Access Compliance Report

Public Rights-of-Way

Intersection ID: 46820	Main Street: NORWAY_SPRUCE_CT	Cross Street: AZALEA_HILLS_DR	Location:	N
ADA ID: AE8983D0639F	Ramp Type: PerpDiag	Initial Pass/Fail: Fail	Overall Compliance: No	Severity Score: 47.5

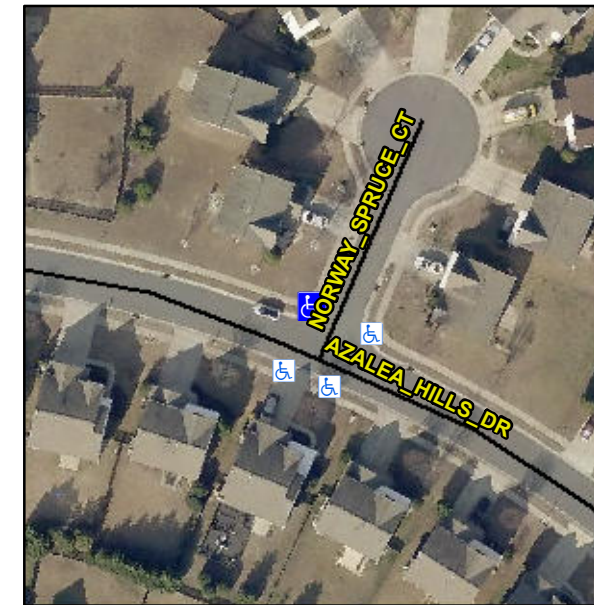
R304.5.1, R304.2.2

Compliance	Description	Data	Compliance	Description	Data
N/A	Ramp Length (in)	47.5	No	Ramp Slope (%)	9.5
No	Ramp Width (in)	31.0	Yes	Ramp XSlope (%)	0.2
N/A	Flare Type LT	N/A	N/A	Flare Type RT	N/A
N/A	Flare Slope LT (%)	N/A	N/A	Flare Slope RT (%)	N/A
N/A	Flare Traversable LT?	N/A	N/A	Flare Traversable RT?	N/A
N/A	Landing Length (in)	N/A	N/A	DWS Provided?	N/A
N/A	Landing Width (in)	N/A	N/A	DWS Contrast?	N/A
N/A	Landing Slope (%)	N/A	N/A	DWS Length (in)	N/A
N/A	Landing X Slope (%)	N/A	N/A	DWS Full Width?	N/A
N/A	Landing Curb? (Y/N)	N/A	N/A	DWS Offset (in)	N/A
N/A	Shared Landing?	N/A			
N/A	Gutter Ponding?	N/A	N/A	Gutter Slope (%)	N/A
N/A	Gutter Lip Ht (in)	N/A	N/A	Gutter X Slope (%)	N/A
N/A	Painted X Walk1?	No	N/A	Painted X Walk2?	No
	X Walk 1 Direction	To SW		X Walk 2 Direction	To SE
N/A	X Walk 1 Width (in)	N/A	N/A	X Walk 2 Width (in)	N/A
	X Walk 1 Slope (%)	3.8		X Walk 2 Slope (%)	0.3
	X Walk 1 X Slope (%)	0.4		X Walk 2 X Slope (%)	0.4

Remove & Replace Curb Ramp With Two New Directional Ramps or Equivalent.
